**TOWN OF ADDISON
BUILDING REPORT**

Facility Name: Wiley Post Office Building

Date: April 10, 2017

Address: 4308 & 4310 Wiley Post Road

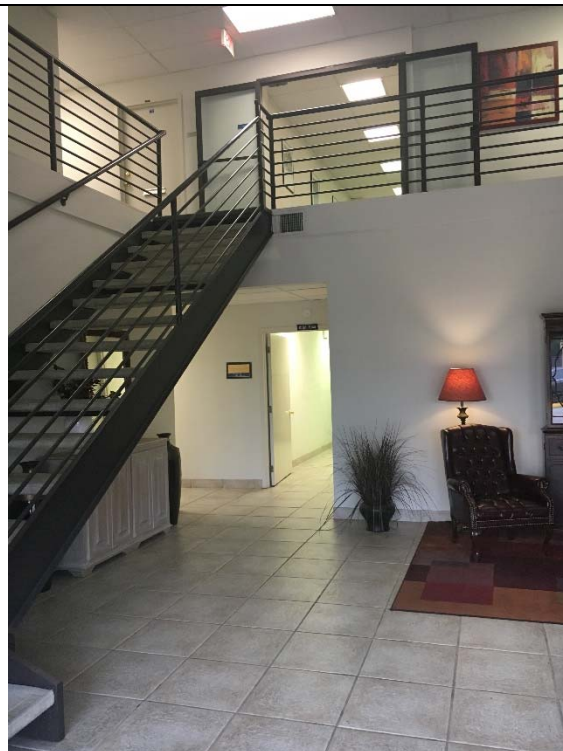
Violation 3 - The ramp provided leading to the main entrance of the building (4310) has a drop off at the corner.

Violation 4 - A step up of 3-1/4" is required for access to the porch at the entrance to the 4308 portion of the building.

Possible Solutions: Add edge protection.

Provide an accessible route to the building entrance.

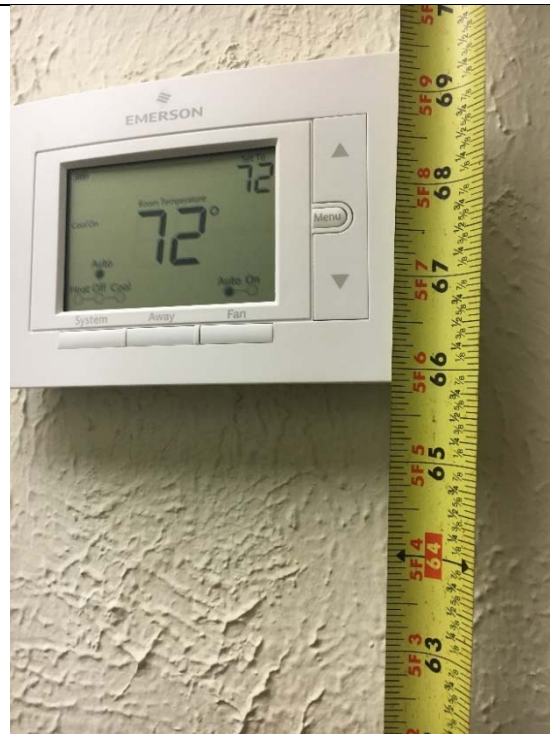
Violation 8 - There is one office door on the first floor that has an opening that is less than the required 32" minimum wide.

Violation 9 - There are 5 office doors on the first floor that does not have the minimum 18" maneuvering clearance on the pull side.

Modify door to provide minimum 32" clear opening.

Modify doo to provide 18" clearance.

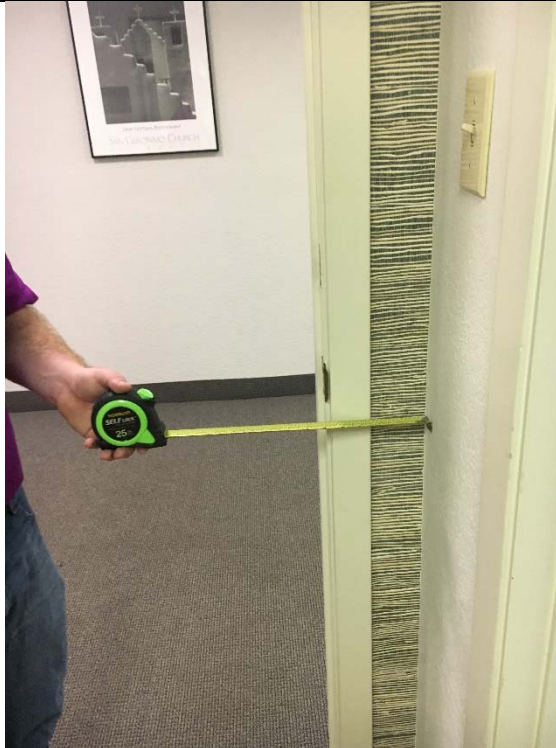
Violation 20 - There is one office door on the 2nd floor that does not have the minimum 18" maneuvering clearance on the pull side.

Violation 21 - The door leading from the main hallway into the lobby on the first floor does not have the minimum 18" maneuvering clearance on the pull side of the door.

Possible Solutions: Modify door to provide 18" clearance.

Possible Solutions: Modify door to provide 18" clearance.

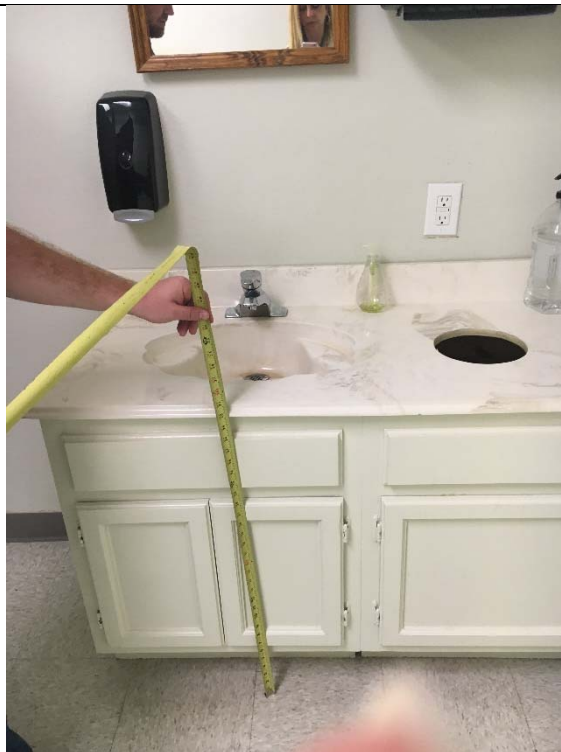
Violation 32 - Men's Restroom first floor of 4310 - The mirror is mounted at 53" above finished floor.

Violation 33 - Women's Restroom second floor of 4310 - The opening leading into the restroom is only 30" wide.

Possible Solutions: Lower mirror so the bottom of the reflective surface is no higher than 40" above finished floor.

Possible Solutions: Modify restroom to ensure a clear 36" wide opening leading into the restroom.

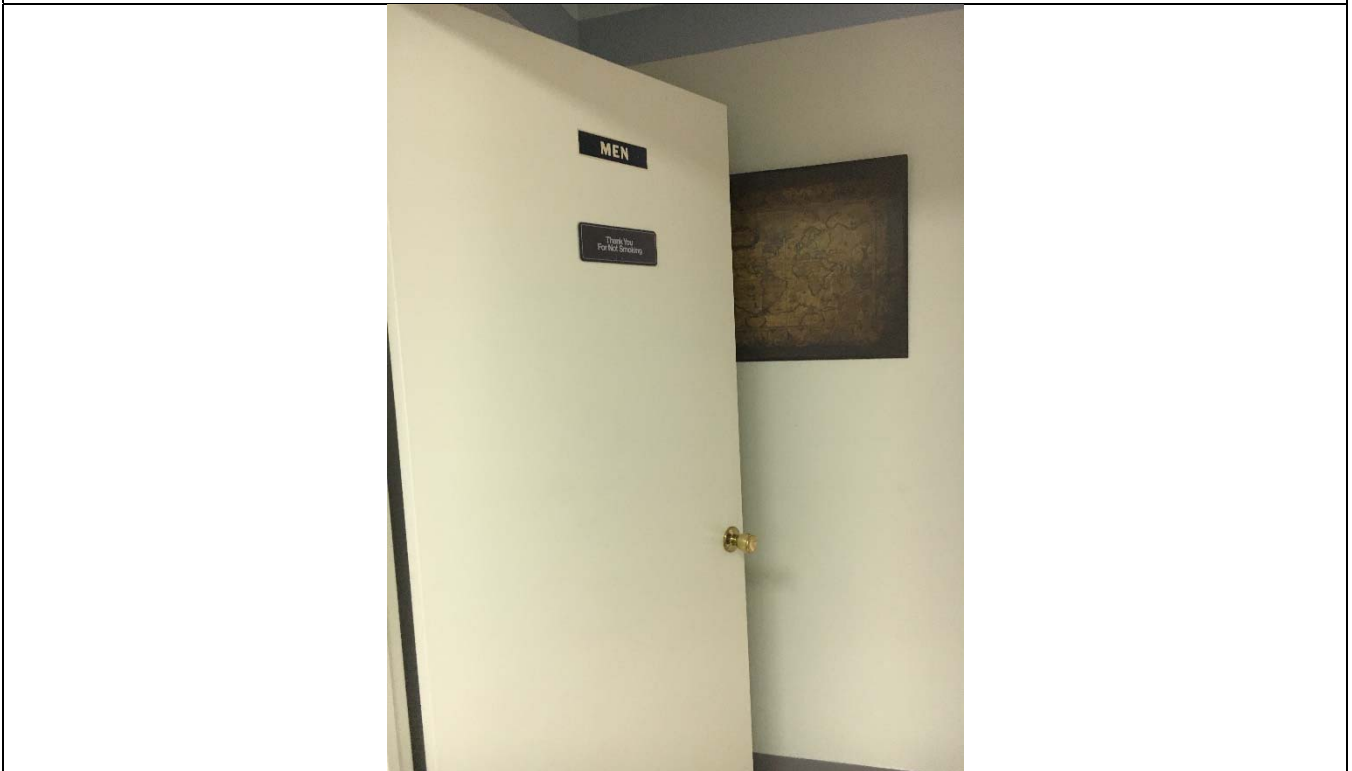
Violation 34 - Women's Restroom second floor of 4310 - Does not have an accessible stall provided.

Violation 35 - Women's Restroom second floor 4310 - There is a cabinet beneath the lavatory blocking the required knee clearance.

Modify toilet room to provide an accessible toilet compartment.

Replace the lavatory with one that provides the required knee and toe clearance for a forward approach.

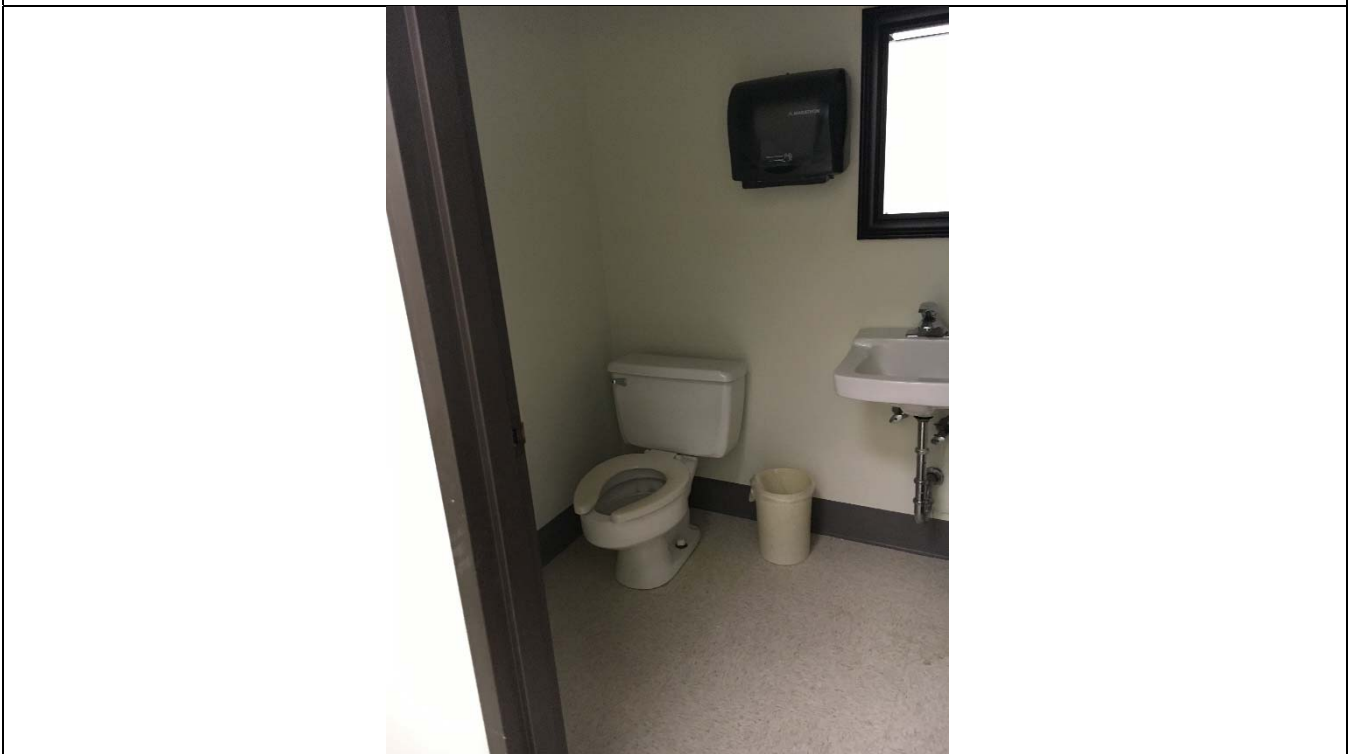
Violation 43 - Men's Restroom first floor of 4308 - Toilet room is not large enough to accommodate a wheelchair turning space.

Violation 44 - Women's Restroom first floor of 4308 - Toilet room is not large enough to accommodate a wheelchair turning space.

Enlarge restroom to accommodate accessible water closet and lavatory and wheelchair turning space.

Enlarge restroom to accommodate accessible water closet and lavatory and wheelchair turning space.

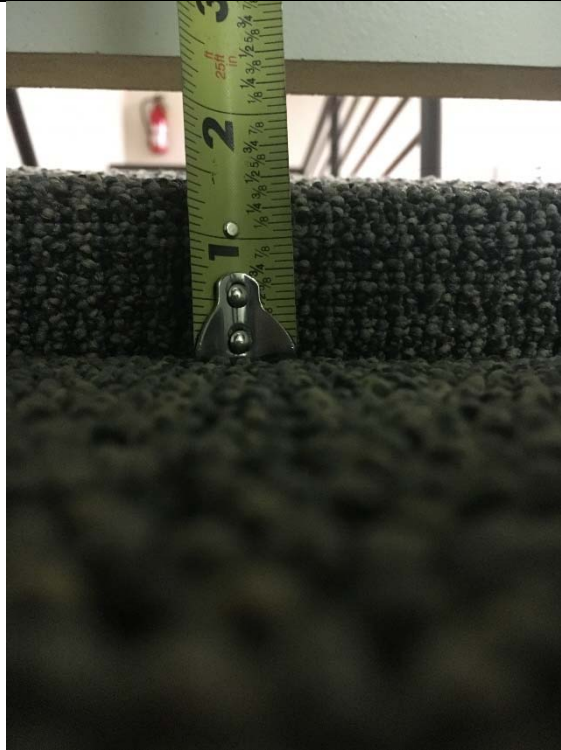
Violation 45 - Men's Restroom second floor of 4308 - Toilet room is not large enough to accommodate a wheelchair turning space.

Violation 46 - Women's Restroom second floor of 4308 - Toilet room is not large enough to accommodate a wheelchair turning space.

Enlarge restroom to accommodate accessible water closet and lavatory and wheelchair turning space.
